## Hornsea Project Three Offshore Wind Farm

Applicant's comments on Written Representations and  
Responses submitted by Interested Parties at Deadline 1

Date: 21<sup>st</sup> November 2018

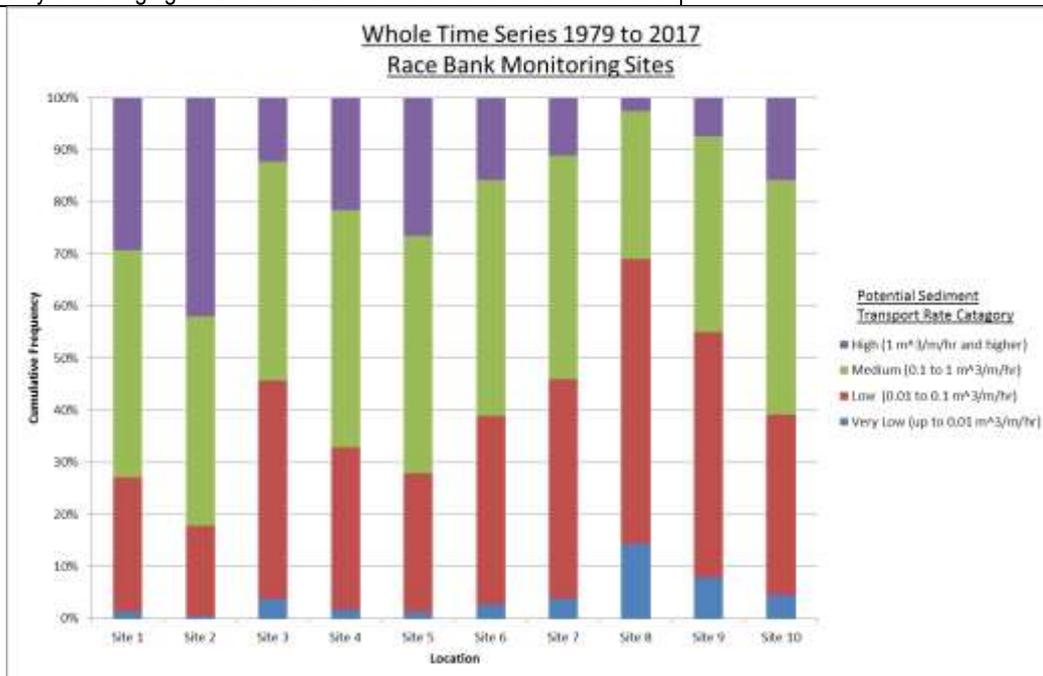
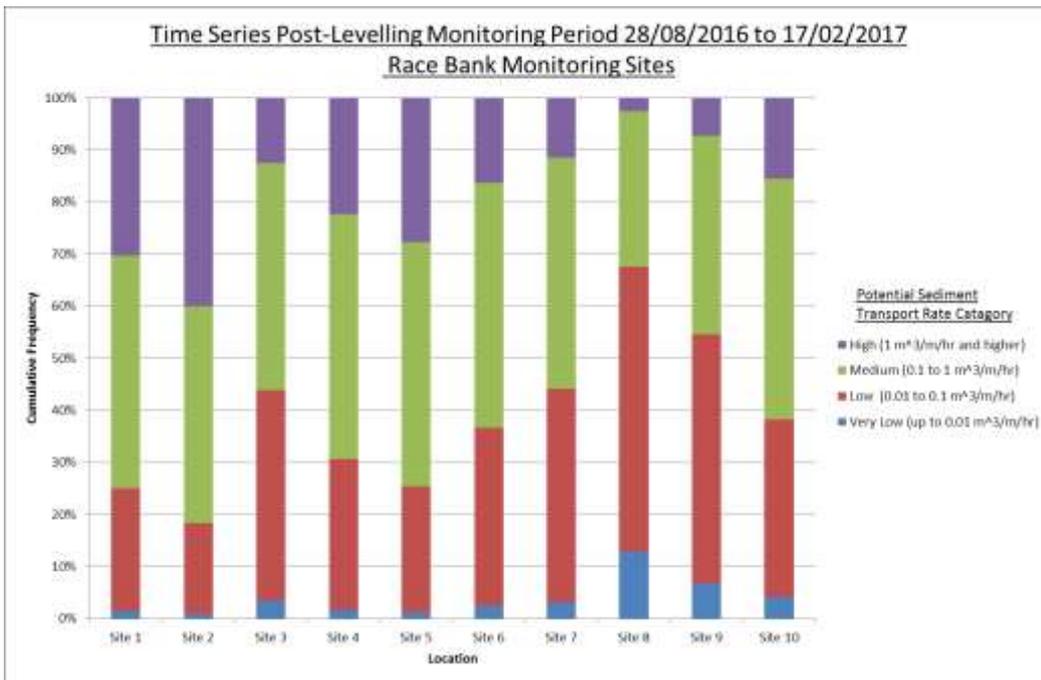
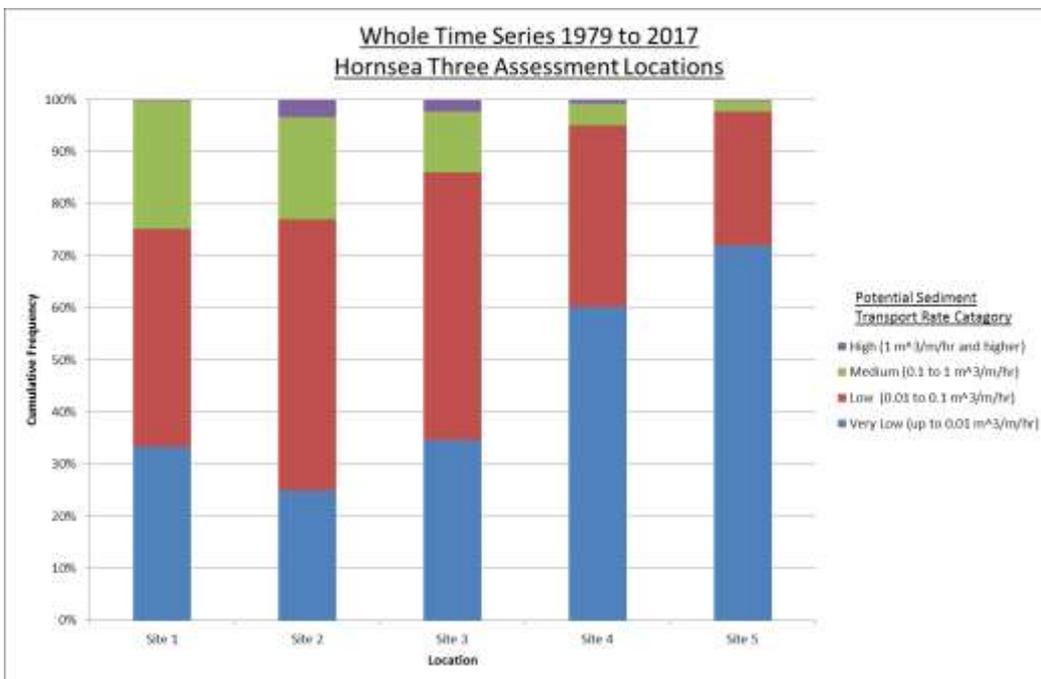
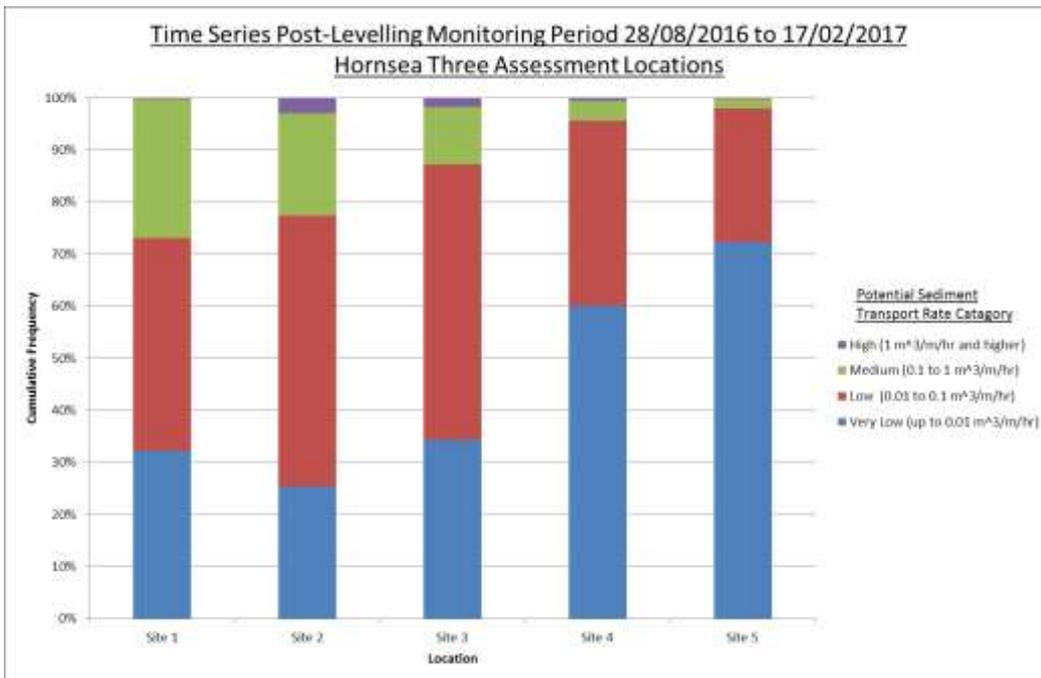
Interested Party's Written Representation	Applicant's Response
<p><b>Cumulative impacts of marine offshore developments in the Southern North Sea</b></p> <p>Large areas of the Southern North Sea that are considered to be suitable sandeel habitat are currently in the operational, construction or planning stages for large offshore windfarm developments e.g. Hornsea 1, 2, 3 and 4, Dogger Bank Teeside A and B (Sofia), Dogger Bank Creyke Beck A &amp; B; East Anglia One North Tranches 1 and 2, East Anglia Three, to name but a few.</p> <p>There is currently very little monitoring being undertaken to investigate the cumulative impacts to sandeel as a result of the construction and operation of offshore windfarms. This makes it difficult to ascertain whether the installation and presence of windfarms is having any effect on sandeel populations. In addition, a lack of post-construction monitoring makes it difficult for windfarm developers to validate ES predictions concerning impacts to sandeel.</p> <p>The current status quo for EIAs is to assume that as the North Sea is a 'large area', impacts to sandeel resulting from a particular development are unlikely to be significant. The rationale given is that there are other areas of suitable habitat in the wider Southern North Sea area which sandeel can inhabit. However, in my opinion, this sort of conclusion overlooks two key issues;</p> <ul style="list-style-type: none"> <li>▫ There are many areas of the wider Southern North Sea area that are not suitable sandeel habitat, e.g. incompatible substrate composition, water depth.</li> <li>▫ Large areas of the Southern North Sea are already being utilised by marine developments including OWFs and aggregate extraction, which further reduces available sandeel habitat.</li> </ul> <p><b>Why collect Particle Size Analysis (PSA) data to monitor sandeel habitats and why observe sandeels caught in grabs?</b></p> <p>In order to carry out sandeel-specific monitoring in the HOW03 area, a dedicated sandeel dredge survey would be required, which would be costly to the developer.</p> <p>As an alternative, analysis of PSA data can be used to demonstrate that the seabed has remained/recovered/returned to an environment which is still suitable as a spawning, nursery ground and habitat for sandeels.</p> <p>Any catches of sandeels from grabs will provide supplementary evidence of their presence in the windfarm and export cable route areas post-construction, thus supporting the findings of PSA data.</p> <p>As a minimum the monitoring approach should look at suitable habitat pre- and post-construction. The data collected should be used to carry out a habitat assessment, i.e. as described in Latto et al. (2013). Ørsted have already undertaken a sandeel habitat assessment using this method to inform the EIA. The PSA sampling needs to be repeated post-construction to map any differences.</p> <p>Although this method would not provide information on sandeel abundance it would indicate availability of suitable habitat and distribution changes.</p> <p>By collecting PSA data and observing occurrences of sandeels in</p>

Interested Party's Written Representation	Applicant's Response
<p>grabs during benthic monitoring at the HOW03 site, Ørsted can support the predictions made within the ES for sandeels.</p> <p>Additionally, PSA data and sandeel observations acquired during post-construction monitoring could be used to support predictions on the impacts to sandeels in future EIAs for other marine developments.</p> <p>Attempting to monitor the potential cumulative impacts to sandeel resulting from offshore marine developments would require many years of study/survey and would need to take into account other factors such as climatic changes and fishing pressures. Instead, PSA and sandeel observation data could potentially contribute to data sets on the cumulative impacts of marine developments in the Southern North Sea.</p> <p>The suggested approach of undertaking PSA and observing sandeels in grab samples will be easier and cheaper to undertake, and is not considered an onerous task as it forms part of a post-construction benthic monitoring programme.</p> <p>This approach is regularly undertaken as part of benthic monitoring programmes for marine aggregate extraction licences, so that licence holders can demonstrate that they are managing an area effectively by providing evidence that the substrate composition they are dredging continues to be a suitable site for sandeel habitat.</p>

Figure 1: See response to Written Representation Comment 7.2. Alternative presentation of the data in plot C.1 of the sandwave clearance clarification note. Showing the cumulative frequency of occurrence for potential sediment transport rate categories at 10 locations in the Race Bank Offshore Wind Farm during the period 1979 to 2017 (see the sandwave clearance clarification note for more details).

Figure 2: See response to Written Representation Comment 7.2. Alternative presentation of the data in plot C.1 of the sandwave clearance clarification note. Showing the cumulative frequency of occurrence for potential sediment transport rate categories at 10 locations in the Race Bank Offshore Wind Farm during the period between pre and post levelling surveys (see the sandwave clearance clarification note for more details).

Figure 3: See response to Written Representation Comment 7.2. Alternative presentation of the data in plot C.2 of the sandwave clearance clarification note. Showing the cumulative frequency of occurrence for potential sediment transport rate categories at 5 locations in the Hornsea Three Offshore Wind Farm during the period 1979 to 2017 (see the sandwave clearance clarification note for more details).

Figure 4: See response to Written Representation Comment 7.2. Alternative presentation of the data in plot C.2 of the sandwave clearance clarification note. Showing the cumulative frequency of occurrence for potential sediment transport rate categories at 5 locations in the Hornsea Three Offshore Wind Farm during the period between pre and post levelling surveys at Race Bank (see the sandwave clearance clarification note for more details).
